Access Compliance Report

Public Rights-of-Way

(Pedestrian Signals)

Intersection ID: N/A	Main Street:	Cross Street: N/A	Location: N/A
ADA ID: 3E92F95BBF9A	Signal Type: Two Push Buttons-Non APS	Overall Compliance: No	Severity Score: BTN 1:N/A BTN 2: N/A No BTN: N/A
Codes/Mitigation Info/Possible Solution		Field Measurements/Component Compliance

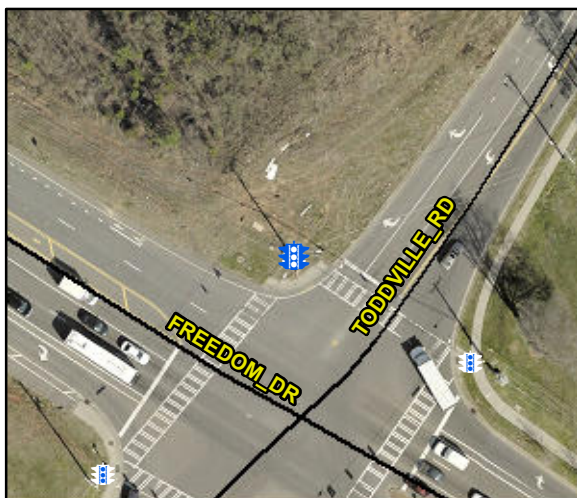
PROW/ADA: TMUTCD 4e.08, R404.7.2

N/A	B 1 Clear Xing Direction?	Yes	N/A	B 2 Clear Xing Direction?	Yes
	B 1 Crossing Direction	To SW		B 2 Crossing Direction	To SE
Yes	B 1 DistanceTo XWalk (in)	0.0	Yes	B 2 DistanceTo XWalk (in)	20.0
No	B 1 DistanceTo Curb (in)	76.0	No	B 2 DistanceTo Curb (in)	76.0
Yes	B 1 Diameter (in)	2.0	Yes	B 2 Diameter (in)	2.0

Possible Solutions: Replace Signal Push Button With APS Button on New Post. Remove & Relocate Sign.
